Project Name UHAUL		Date 4-13-17
Location State Route 14 Horseheads, NY		Permit #NYR11A438
Weather Conditions Sunny		Entry Time: 9:56
On-Site Representative Present: L. Crooker, Welliver D. Reynolds, Edger		Exit Time: 10:48
Construction Site Notes:		
-parking lot grading and inside building work occurring at site.		
REMINDER		
Contractor is responsible for walking the site daily to ensure swppp compliance.		
Yes	No	N/A
	X	All erosion and sediment control measures installed/constructed
	X	All erosion and sediment control measures maintained properly
	X	Are there currently more than 5 acres disturbed w/o prior approval
	X	Have stabilization measures been initiated in inactive areas
X		Are permanent stormwater control measures being implemented
	X	Was there a discharge into the receiving water on the day of inspection
	X	Evidence of turbidity or oil in the receiving waters
X		Are weekly inspections being performed?

PROJECT:	UHaul
	Town of Horseheads
	Municipal inspection
	April 13, 2017
BY:	Jessica Verrigni, CPESC, CPSWQ

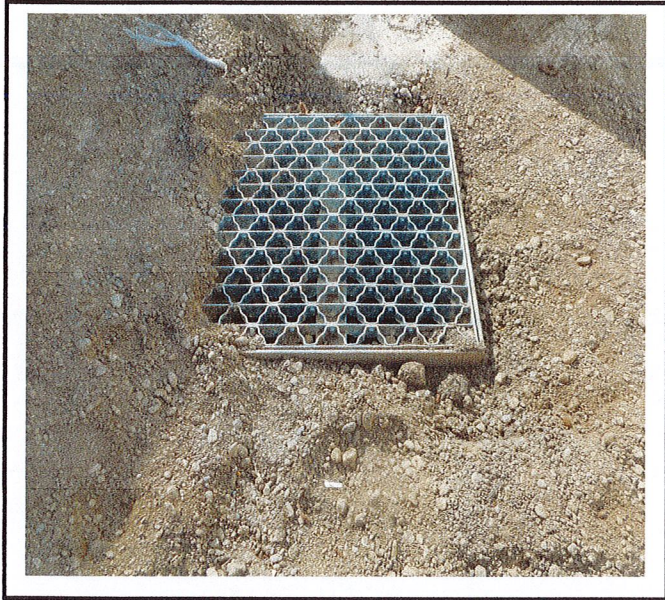
X		Are the inspections being performed by a qualified individual?
Corrections Needed:		
*QUALIFIED INSPECTION REPORT HAS NOTED THESE PROBLEMS NUMEROUS TIMES. CONTRACTOR IS TO IMPLEMENT CORRECTIVE ACTIONS WITHIN 24 HRS OF RECEIPT.		
DROP INLET PROTECTION not installed on 6 drainage inlets leaving underground system vulnerable to sediment accumulation.		
SILT FENCE not being maintained. It is torn, buried and splices broken.		
CONCRETE WASHOUT is not installed. Concrete piles and wash water throughout site.		
POLLUTION PREVENTION- construction debris on outside of silt fence in all over site.		
CONSTRUCTION ENTRANCE- sediment tracked through parking lot with potential to get on to Miracle Mile. Make sure it is being cleaned up daily or a construction entrance is installed if this becomes a problem in the wet season.

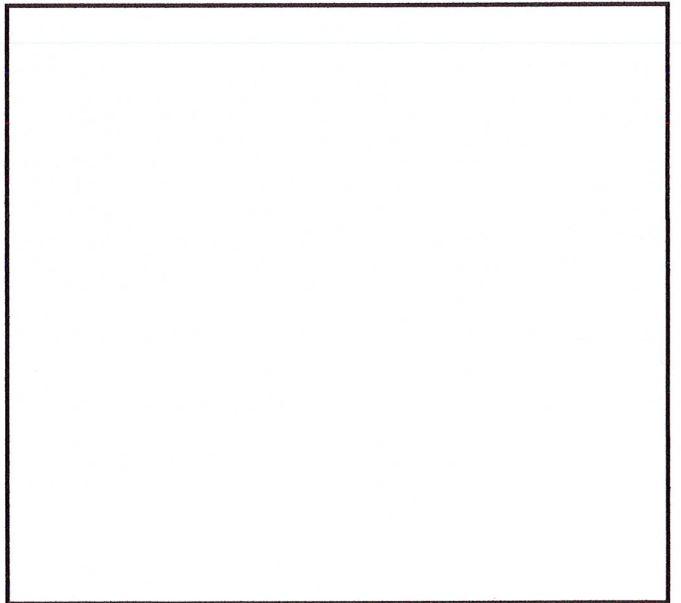
Entrance will require maintenance before tracking onto road occurs.
